**HENDY WIND FARM: Land Off A44 SW Of Llandegley Llandrindod Wells Powys**

**Application for discharge of condition 27 from P/2014/0672 (APP/T6850/A/17/3176128): Engineering drawings for construction traffic access to site**

**CONDITION 27: Engineering drawings for construction traffic access to site**

### 3) Road across field adjacent to A44 – extract from ES Fig 1.2.9

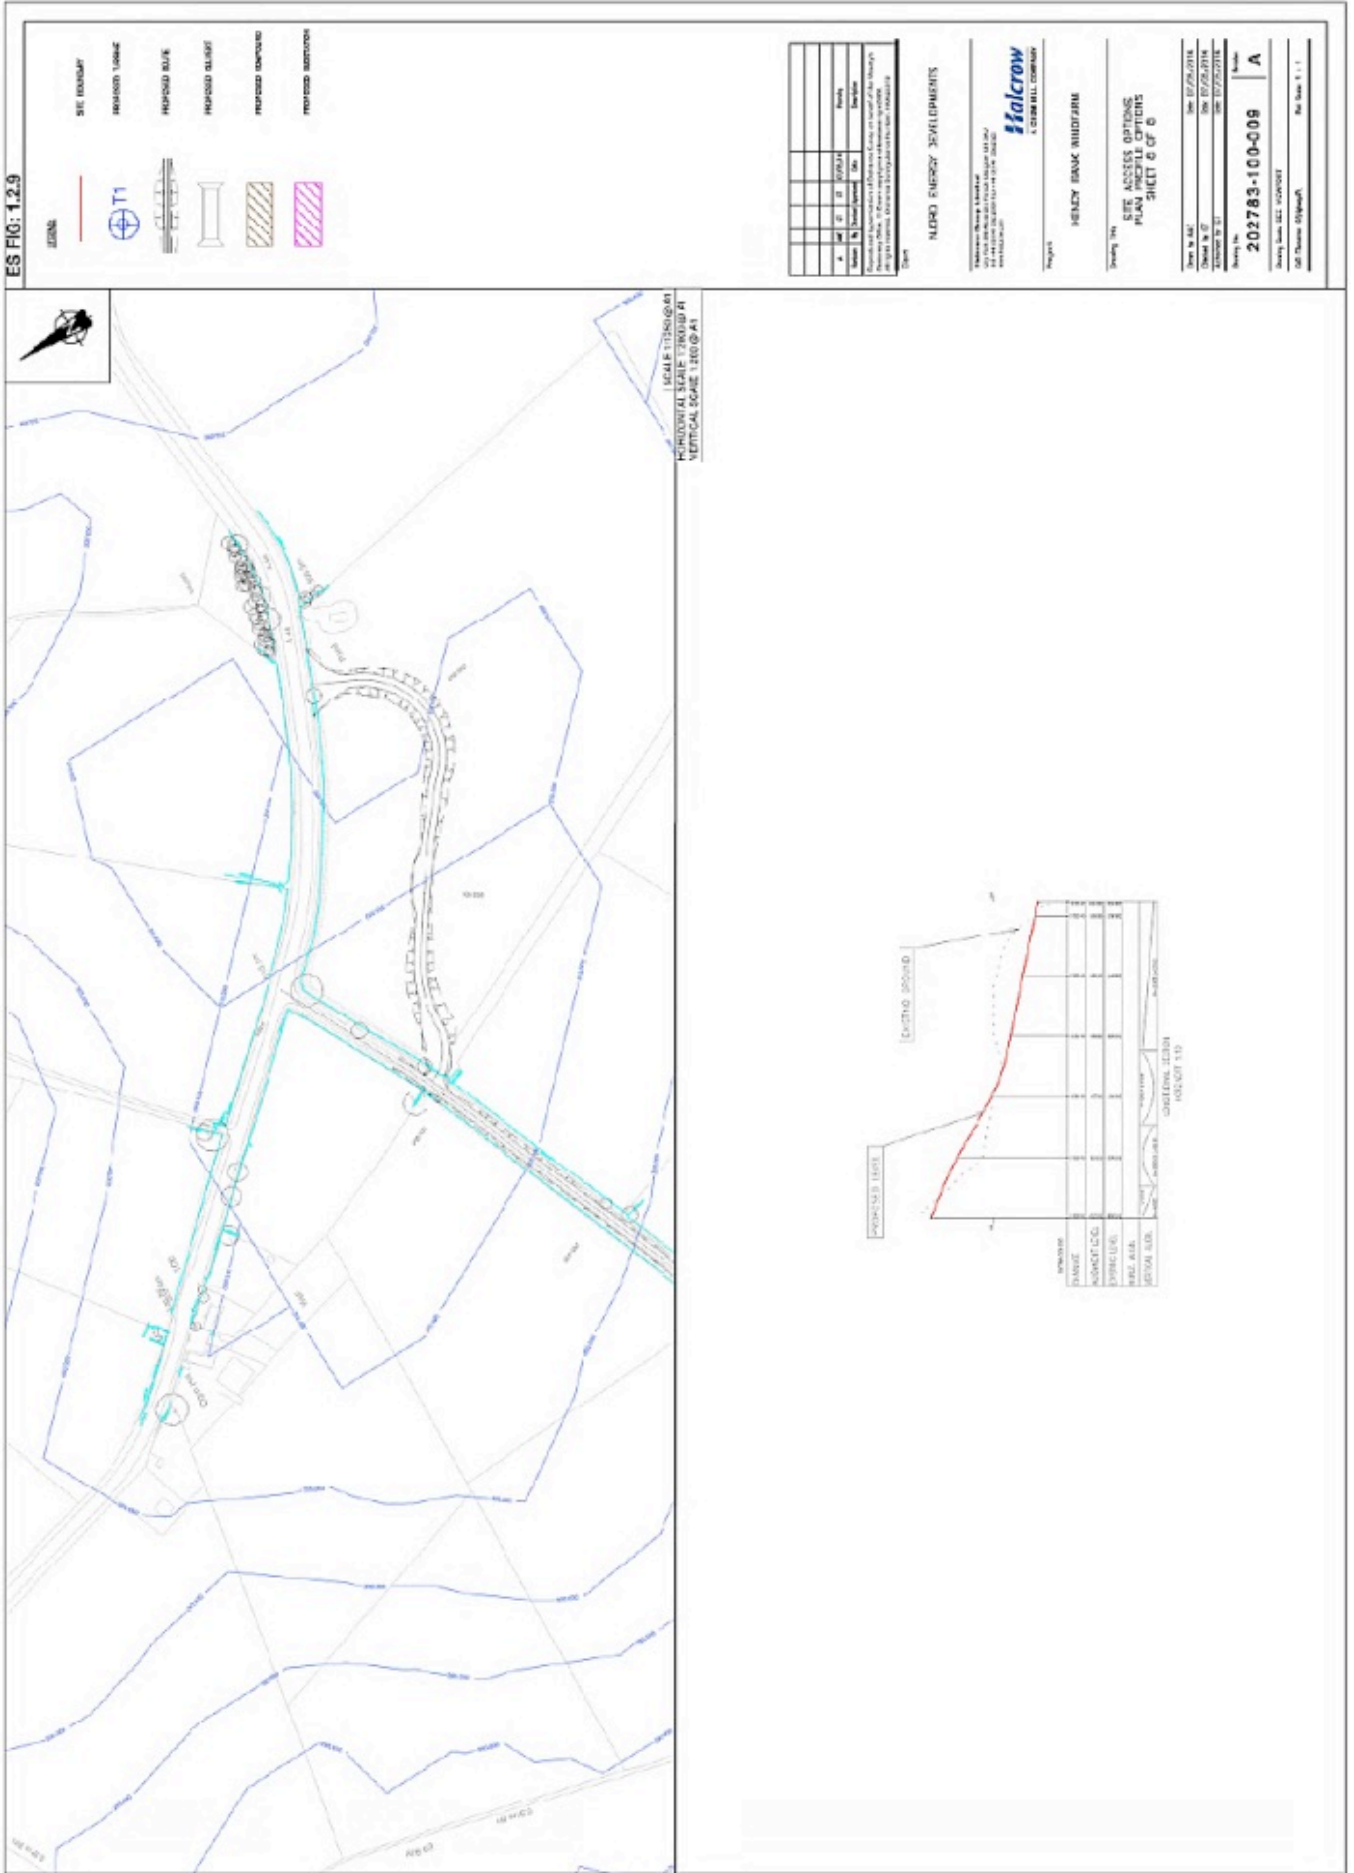
**2) and 3) Modifications to U1574 and new road section in field:** No information has been supplied for 2) beyond some blue pen markings on ES Fig 1.2.2. Minimal information is supplied for 3) in ES Fig 1.2.9 and ES Fig 13.1. Extracts from Figs 1.2.2 and 1.2.9 are reproduced below. Without even basic technical details, the developer’s assertion that works are reversible can have no weight. It’s unclear whether the U1574 is to be widened, whether there will be encroachment on third party land, whether hedges and trees will be removed. Engineering drawings

are clearly required. The exact nature of the new road across a field, and of its junction with the A44 are wholly unclear.
